# Work Order ID 90308

Item ID: D3016-041 Accept \*N900040100\* Setup Start \*NS1\*  
 Revision ID: Stop \*NS2\*  
 Item Name: Seat Frame Assembly  
 Start Date: 9/17/12 Start Qty: 1.00 \*1\* Cust Item ID:  
 Required Date: 10/12/12 Req'd Qty: 1.00 \*1\* Customer:  
 Reference:

DESIGN CP	DRAWN BY CP	DART AEROSPACE LTD HAWKESBURY, ONTARIO, CANADA	
CHECKED #	APPROVED #	DRAWING NO. D3016	REV. A SHEET 1 OF 3
DATE 01.05.18		TITLE SEAT FRAME ASSEMBLY	SCALE NTS
A	01.05.18	NEW ISSUE

DRAWING NO. D3016	TITLE SEAT FRAME ASSEMBLY	REV. A	DART AEROSPACE LTD ENGINEERING ORDER	D.E.O. NO. D3016-A-1	SHEET NO. SHEET 1 OF 1	SCALE NTS
DRAWN 1	CHECKED UP	MFG. APPR. R	APPROVED MAP	DE APPR. H		
DATE 10.01.29	DATE 10.01.29	DATE 10.01.29	DATE 10.01.29	DATE 10.01.29

**D3016-11 SADDLE**

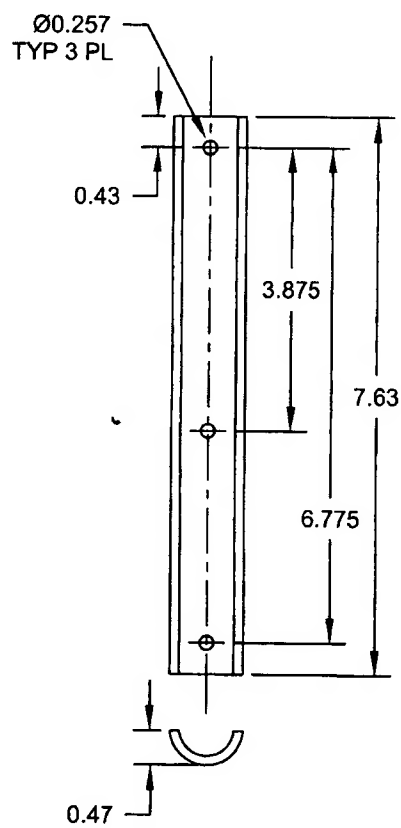
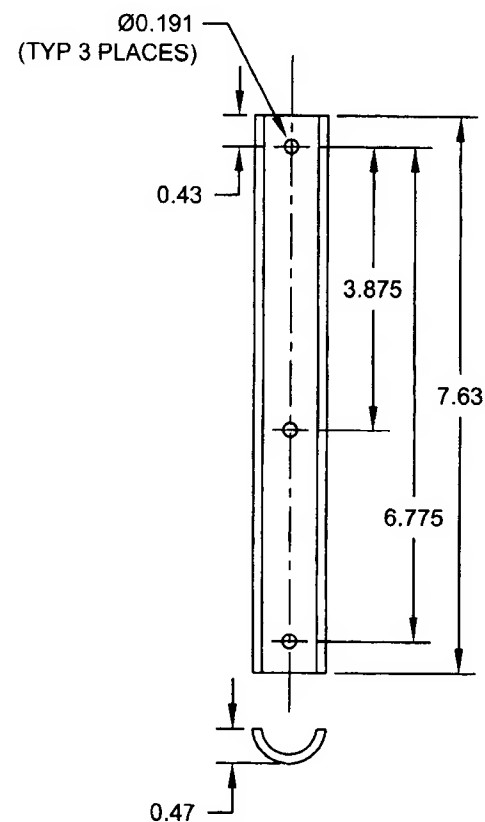
TO REVISE D3016-11 SADDLE'S HOLE SIZES

DETAIL D3016-11 SADDLE (SHEET 3): Ø0.257 TYP 3 PL WAS Ø0.191 (TYP 3 PLACES) AS SHOWN:
